**BEFORE THE BOARD OF PATENT APPEALS
AND INTERFERENCES**

Application Number: 10/718,086
Filing Date: November 19, 2003
Appellant(s): CLEMENS, READE

EXAMINER'S ANSWER

FIG. 2

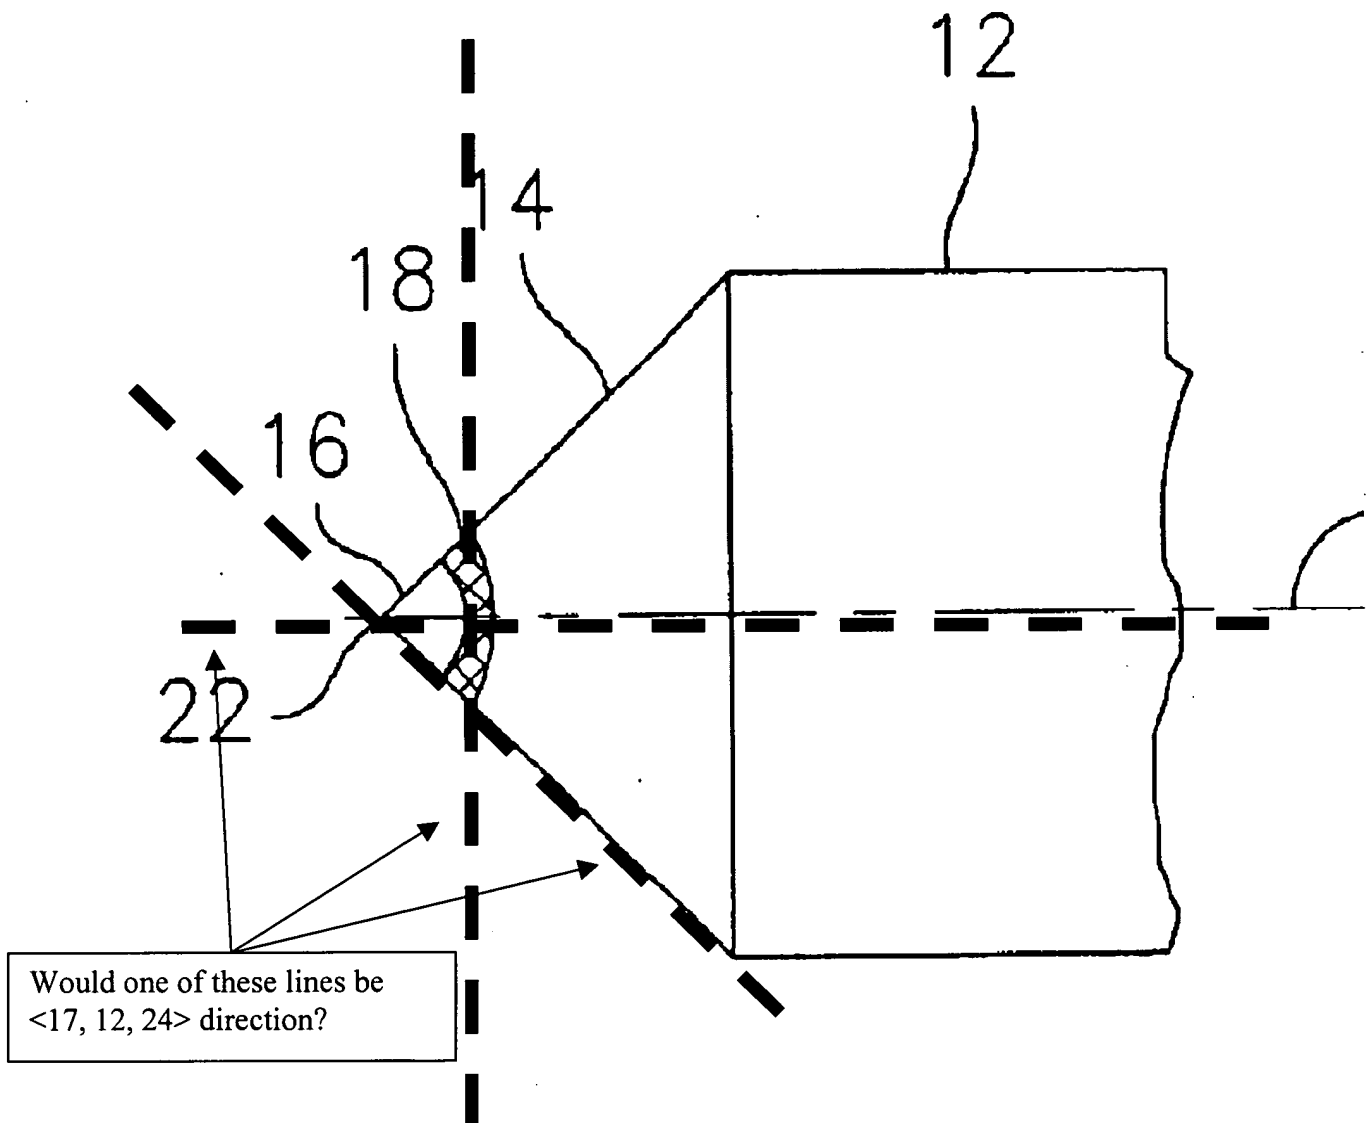
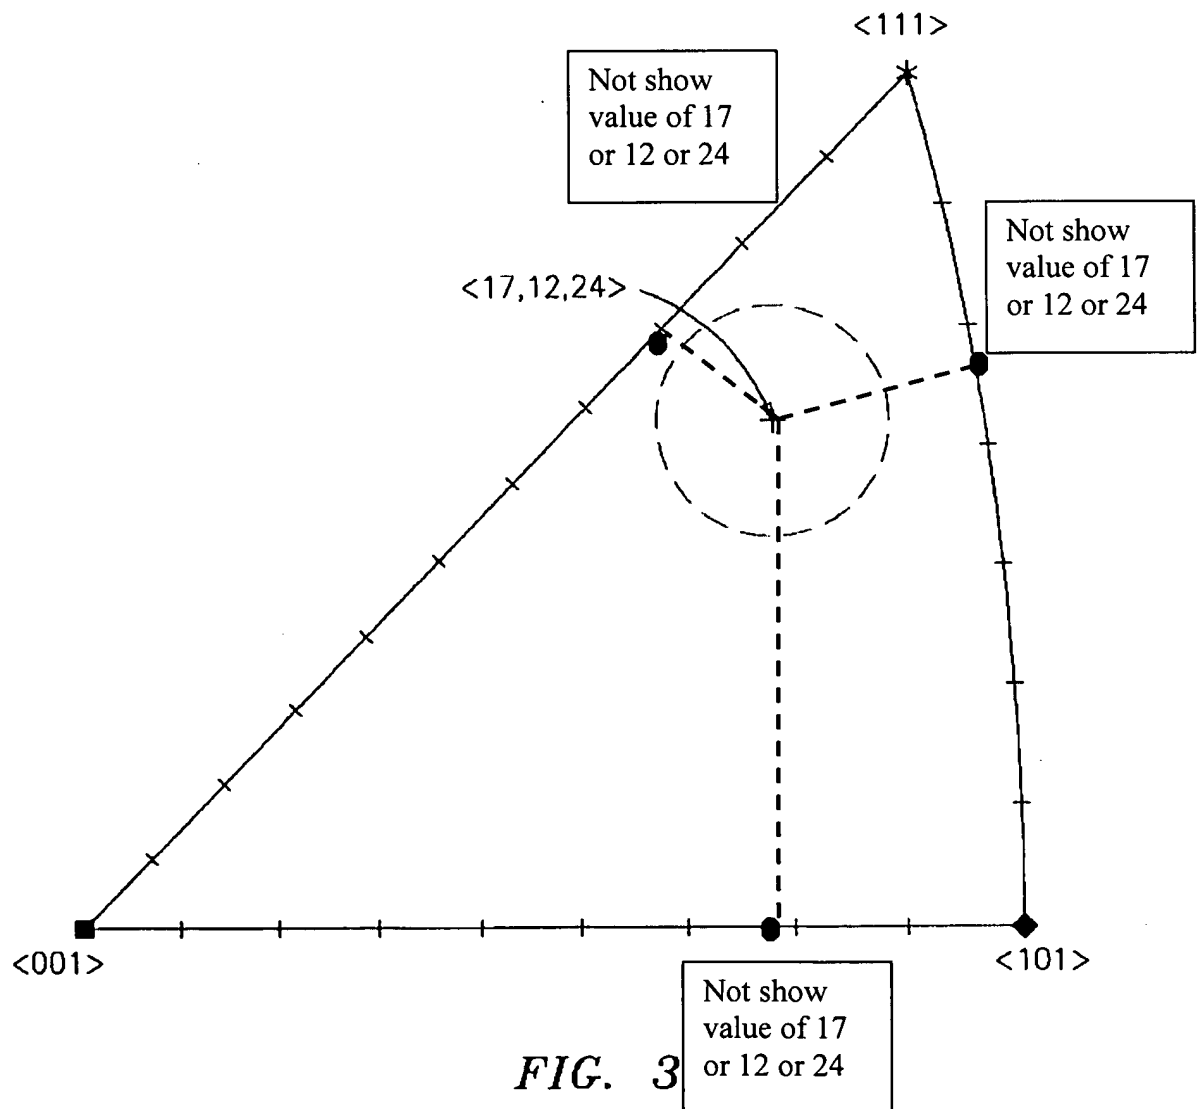
The Applicant does not provide enough information of the <17, 12, 24> direction so that one of ordinary skill in the art can make and use the claimed invention. For example, would the

cutting tip 22 in Fig. 1 of the disclosure not be tilted more than 8 degrees with respect to the shank axis 24 is what the Applicant claims? Or would one of the surfaces of the indenting tip be <17, 12, 24> direction? See below sketch.

The Applicant asserts that Fig. 3 represents the $\langle 17, 12, 24 \rangle$ direction. However, projecting perpendicular lines from the coordinate $\langle 17, 12, 24 \rangle$ does not produce the same value of the coordinate. See below sketch.

FIG. 8

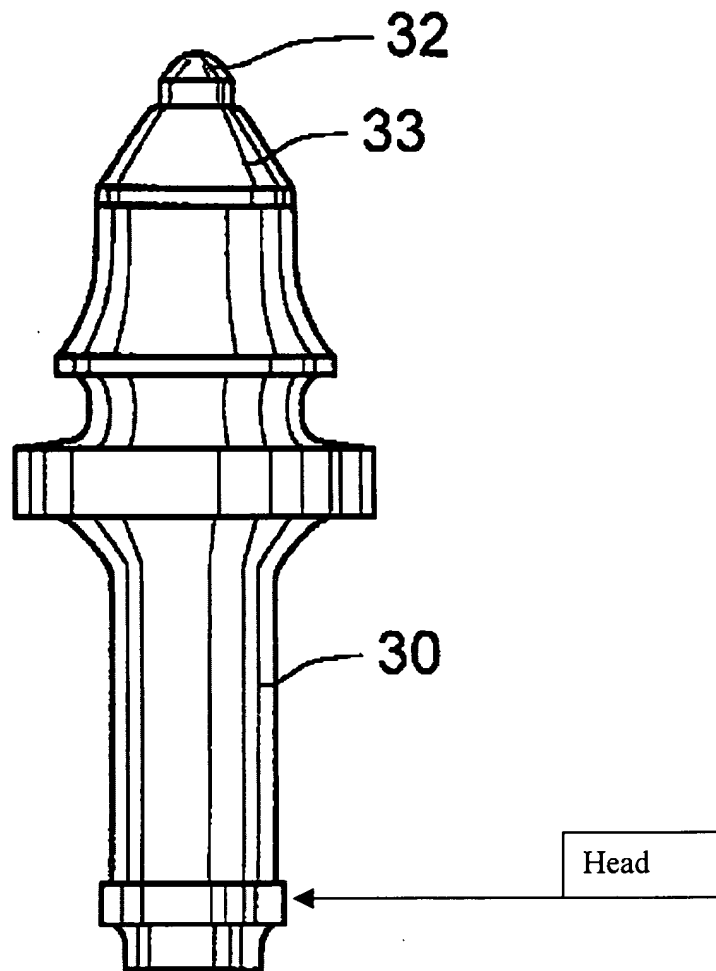
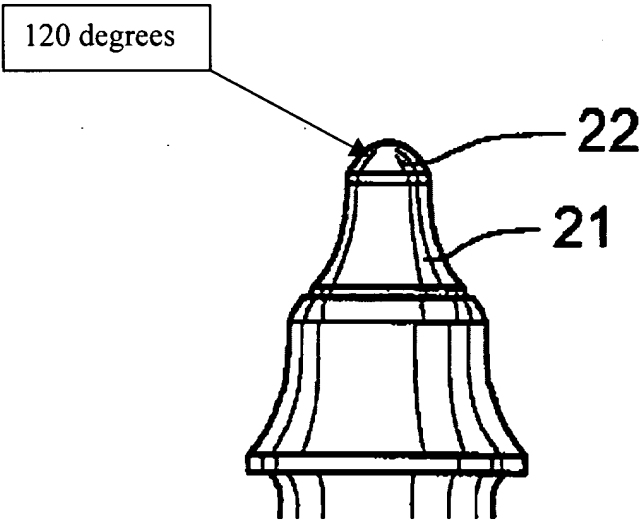
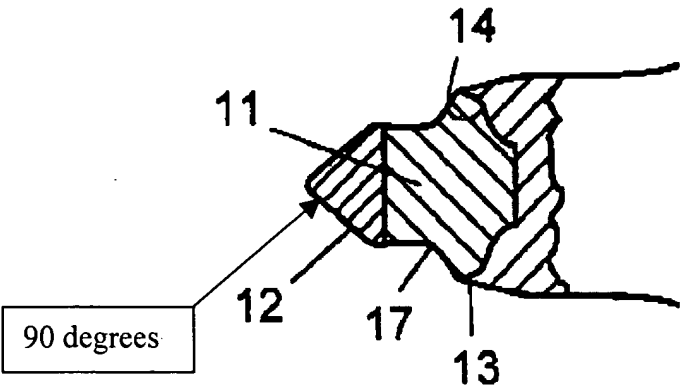
Anderson teaches forming a shank to which a diamond is attached from steel (col. 5, lines 5-10); a head formed adjacent a second end of the shank (see Fig. 8); a head which is wider than the shank (see Fig. 8); the use of a single crystal diamond (there is one indenting tip and it is covered by diamond coating; therefore the indenting tip is a single diamond); a diamond which in a final ground state has a length greater than an indentation depth to be imparted to a part to be marked (it is inherent.); a diamond having a 90 degree included angle conical point (see Fig. 3); a diamond having a 120 degree included angle conical point (claim 10); a brazing alloy which wets both the diamond and the material forming the shank (see the Abstract and col. 3, lines 29-54); and a shank with a tapered tip end 12 (see Fig. 3) to which a diamond is attached.
